ADDENDUM

To:	All holders of Solicitation documents for the below-referenced Solicitation.
Date:	March 18, 2026
Addendum No.:	No. 5
Solicitation No.:	IFB26-49
Solicitation Title:	Fire Station 4 Replacement Project
Contact Name:	Jeff Engelhardt
Contact Title:	Management Analyst
Contact Phone No.:	505.622.8056
Contact E-Mail:	jeff.engelhardt@losalamosnm.gov

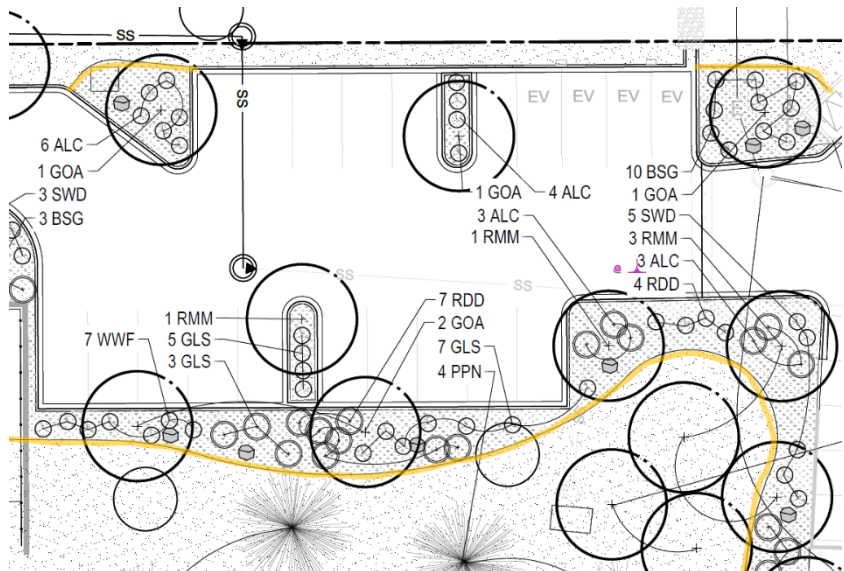
31	Detail 341/ S302 note about backfill not higher than 4' only applies to the basement storage area and not apparatus bay due to no slabs being present.	This is correct, however see additional response to 29 above for intended requirements at the apparatus bay retaining walls.
32	On page 16 + 17 C-013 + C-014 there are 2 phases called out. There is no reinforcing details called out for the exterior concrete sidewalk or SOG. Or Utility pad. Please provide	Exterior concrete equipment pad detail is 364 on sheet S-303

reinforcing size and spacing if required.	
33	Civil details on C-022 marked 00% REVIEW Not for Construction and all Civil Site work not called out in the Structural drawings will be omitted from bid unless reinforcing size and spacing is provided.	Hold #5 rebar continuous 6" O.C.
34	On page 057- S-200 the main level BOF is called out at 80'-0" BFF from Grid D to Grid K and Grid 5 to 11. The cut 324 on S-301 says to coordinate with Plan Elevations which would be approximately 95' to 96' BOF from Grid 5/D to grid G /11 and then start stepping down to 80' BOF. Please advise if we are to use the elevations given or raise the BOF as noted in the detail.	See responses to 27 & 28 above.
35	Please provide detail on where to put the steps (if required) including tying into lower foundation.	For bid purposes, the only current footing step locations are noted around stair bump out along grid K. Additional footing steps can be considered in the future for potential cost savings as noted in response to 27 above.
